Addendum 126 – Regulation No. 127

Revision 3 - Amendment 3

Supplement 2 to the 03 series of amendments to the Regulation – Date of entry into force: 5 January 2024

Uniform provisions concerning the approval of motor vehicles with regard to their pedestrian safety performance

Figure 12
Windscreen Test Area

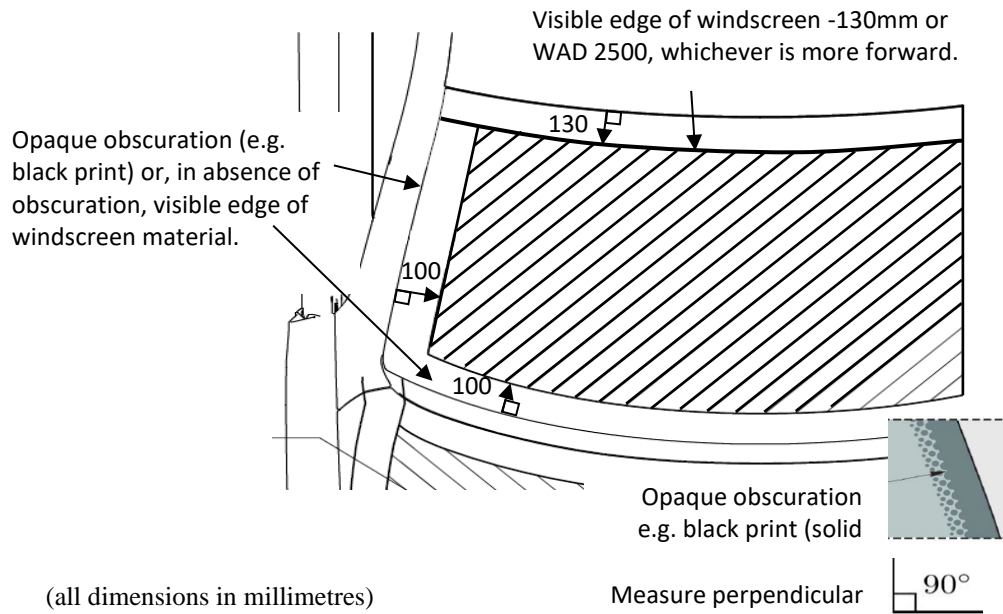
Paragraph 2.44., amend to read and insert Figures 12 and 13:

"2.44. "Windscreen test area" is an area on the outer surface of the windscreen. It is bound (see figure 12):

- (a) In the front, by a line 100 mm rearward to the opaque obscuration of the windscreen. In case of absence of the opaque obscuration, the line is measured from the front visible edge of the windscreen material.
- (b) In the rear, by a WAD 2,500 or a line 130 mm forward to the rear visible edge of the windscreen material, whichever is more forward at a given lateral position.
- (c) At each side, by a line 100 mm inside the opaque obscuration of the windscreen. In case of absence of the opaque obscuration, the line is measured from the side visible edge of the windscreen material.

For (a) and (c): the distances of 100 mm are to be measured with a flexible tape held tautly along the outer surface of the vehicle at an angle of 90° to the tangent line to the opaque obscuration limit or in case of absence of the opaque obscuration, from the visible edge respectively.

For (b): the distances of 130 mm is to be measured with a flexible tape held tautly along the outer surface of the vehicle at an angle of 90 ° to the tangent line to the rear visible edge of the windscreen.

Figure 13
Upper Corner Definition with "Shortest Distance"

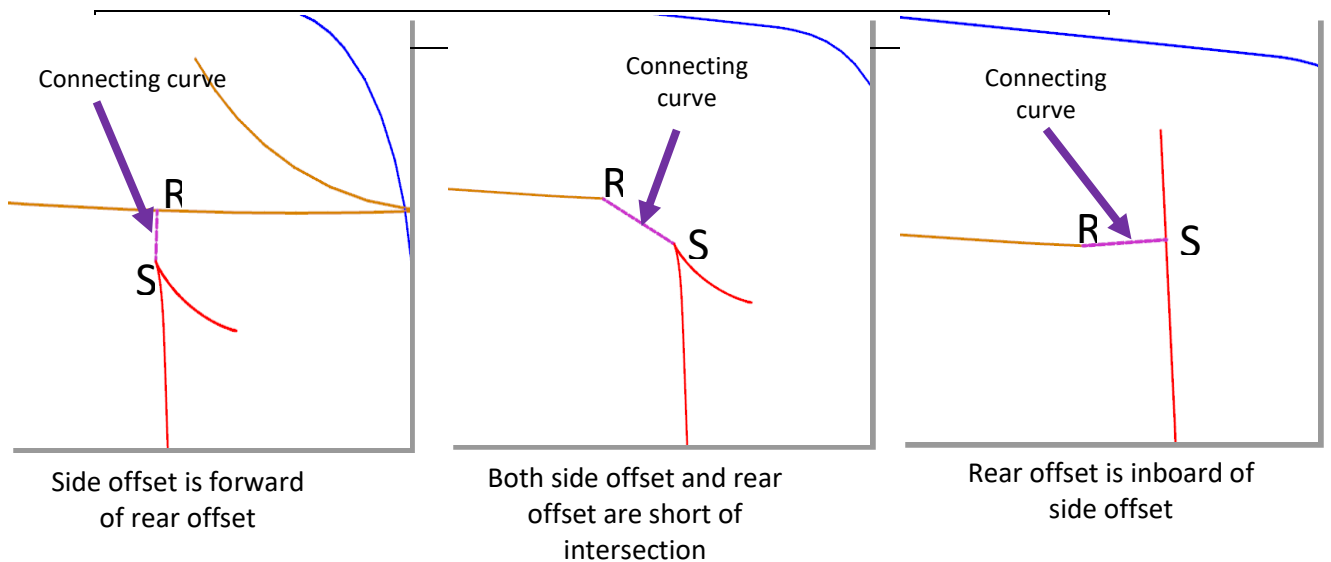
Depending on the geometry, in case there is no intersection between (b) and (c), resulting in an open test area, then the marking shall be modified using the shortest distance to close the open test area (see figure 13).

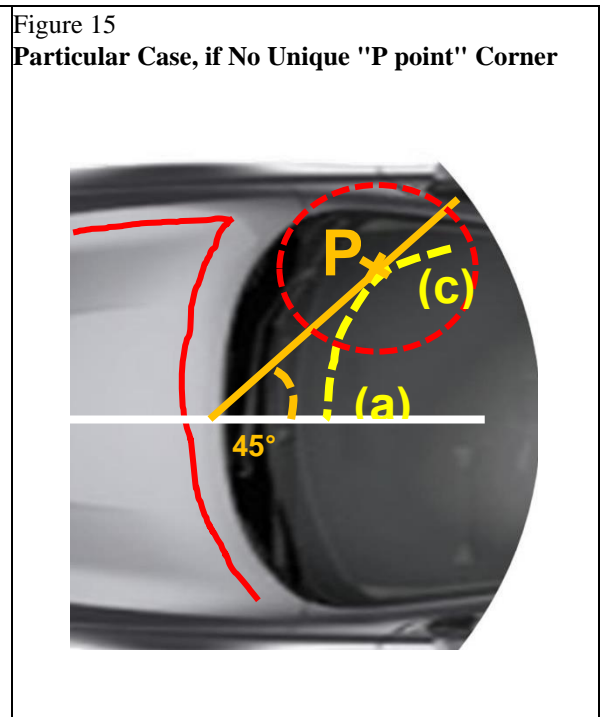
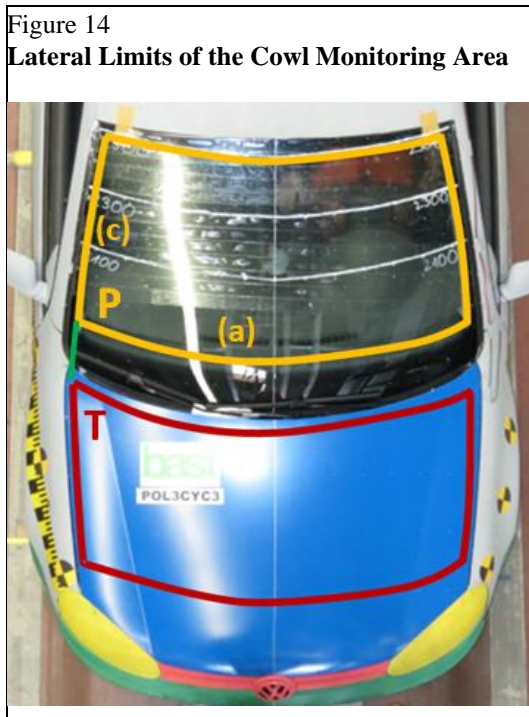
Paragraph 2.45., insert Figures 14 and 15 and amend to read:

At each side, the cowl monitoring area is bound by the TP line (see figure 14), where:

- (a) the "T point" is the rear corner of the bonnet top test area; and
- (b) the "P corner point" is the lower corner of the windscreen test area; using a flexible tape held tautly from point T to P.

If there is no unique "P point" where the lines defined in 2.44 (a) and (c) intersect, then the "P point" is defined by the first contact of a vertical plane intersecting the vertical longitudinal vehicle centre-plane at an angle of 45° with the (a)-(c) transition of the windscreen test area boundary, as shown in Figure 15.

Figure 16
Jerk Criterion Graph and Formula

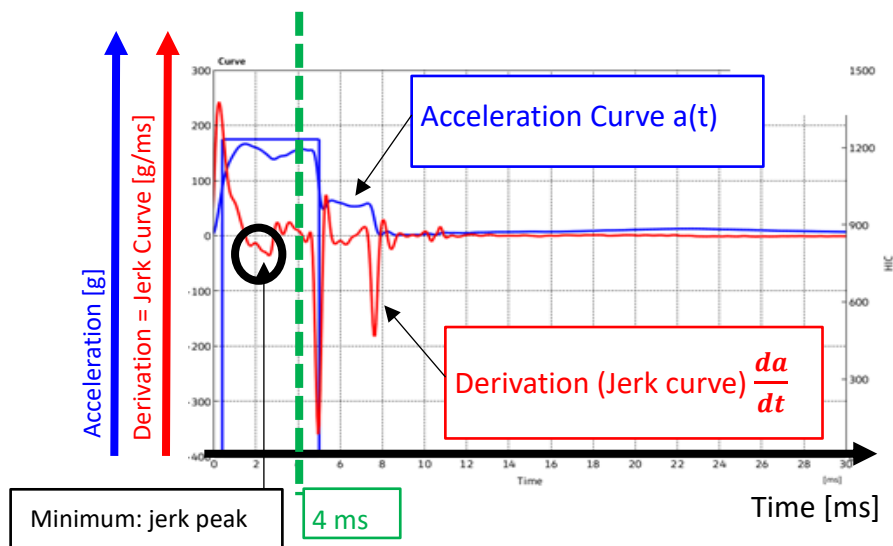
Paragraph 2.48., insert Figure 16 and amend to read:

- (a) The absolute value of the minimum value of the derivation of the headform acceleration versus time is less than 180 g/ms within the first 4 ms after the initial contact of the headform to the windscreen, as shown in Figure 16 ; or

$$\left| \min \left(\frac{da}{dt} \right) \right| < 180 \text{g/ms, for } 0 < t < 4 \text{ms}$$
